UNITED STATES PATENT AND TRADEMARK OFFICE

Office Action Summary	Application No. 10/564,226	Applicant(s) THOEMMES, FRANZ	
	Examiner Jason J. Boeckmann	Art Unit 3752

DETAILED ACTION

Examiners marked up figure 9

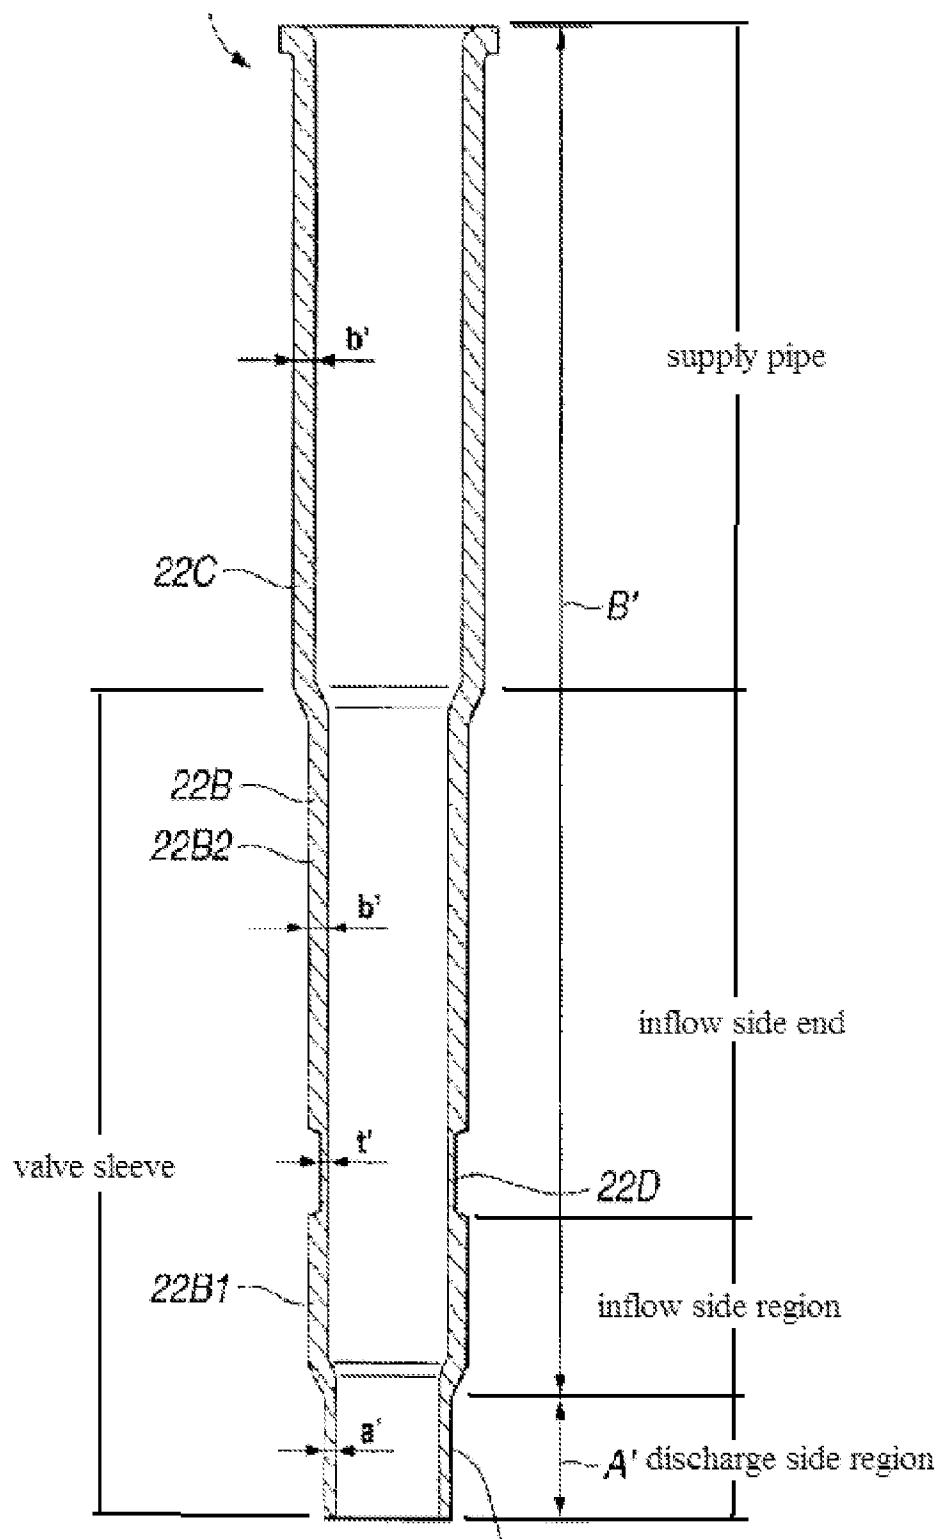
Kobayshi et al. shows a fuel injector (1) comprising; a valve needle (26) an armature (7C) forming an axially movable valve port together with the valve needle (7A), a restoring spring (9) acting upon the armature, a magnetic coil (11) cooperating with the armature, a valve-seat body (5), a valve closure member (7B) which forms a sealing seat with the valve seat body and; a valve sleeve (22) surrounding the armature and the

valve needle, a wall thickness of the valve sleeve varying across its axial direction (fig 9), wherein the wall the wall thickness of the valve sleeve decreases in a discharge direction of a fuel (figure 9), wherein an outer diameter and a radial cross section of the valve sleeve decrease between an inflow-side region and a discharge-side region on a color (figure 9), wherein the radial cross section and the wall thickness of the inflow-side region are constant from the collar to an inflow-side end of the valve sleeve (figure 9); wherein the decreased radial cross section and decreased wall thickness of the discharge-side region are constant form the collar to a discharge-side end of the valve sleeve (see examiners marked up figure below), and wherein the inflow side region of the valve sleeve is formed in one piece with a supply pipe (see examiners marked up figure 9 below).

Additionally, as to the recited process of forming the valve sleeve in one piece with a supply pipe, such is a product by process recitation. The patentability of a product does not depend on its method of production. If the product in the product-by-process claim is the same as or an obvious variant from a product in the prior art, the claim is unpatentable even though the prior product was made by a different process (see MPEP 2113).
